Monticello Nuclear Generating Plant
Docket 50-263
Renewed Facility Operating License
License No. DPR-22

Monticello Extended Power Uprate (USNRC TAC MD8398):
Acceptance Review Supplemental Information Package 4

Reactor Inspection Branch
Questions and Responses

Figure 1 - Dose Rate as a Function of HWC Injection Rate (Typical)

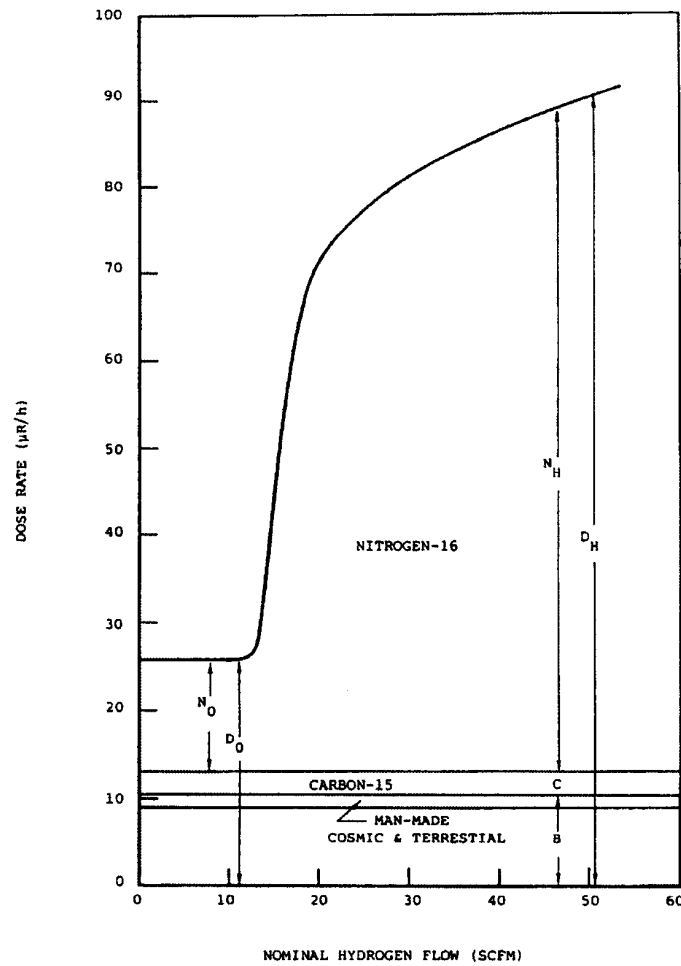
Describe the contribution and effects of hydrogen water chemistry (HWC) (N-16) to the radiation doses (both pre-EPU and post-EPU) to members of the public onsite.

Table 9 - Effects of HWC		
Item	Assumption	Ref./Basis
1	The increase in skyshine dose rate at EPU conditions is driven by N-16.	<p>N-16 is the predominant radiation source in BWRs, especially in plants with HWC. N-16 production rate increases in proportion to the increase in thermal power (approximately 13%). At a constant HWC injection rate the feedwater hydrogen concentration entering the reactor would decrease slightly. However, this effect is offset by the increase of radiolysis which produces free hydrogen from the reactor coolant. The increase in steam flow at EPU (14.8%) offsets this increased N-16 production by dilution. So N-16 concentration in steam exiting the RPV at EPU (without an increase in HWC Injection rate) would remain constant.</p> <p>Increased steam flow rates decrease transit time for N-16 in steam to various points in the BOP. This reduction in transit time allows less time for decay of N-16 and results in increased radiation levels further downstream in steam piping and steam systems.</p>

2	HWC injection rate will be increased by approximately 14.8% (the EPU increase in feedwater flow rate) to maintain feedwater hydrogen concentration at current levels.	Reasonable assumption, based on design basis for HWC. No actual increase has been planned or identified at present.
3	The dose rate due to N-16 increases linearly with the increase in hydrogen injection rate.	EPRI Report NP-4621 (See Figure 1 below) shows the typical characteristic response of steam radiation levels with increasing hydrogen injection rate. MNGP radiation operating hydrogen injection levels place the plant in the upper region of this curve where it is conservative to predict a linear increase in radiation levels with increasing injection rate.
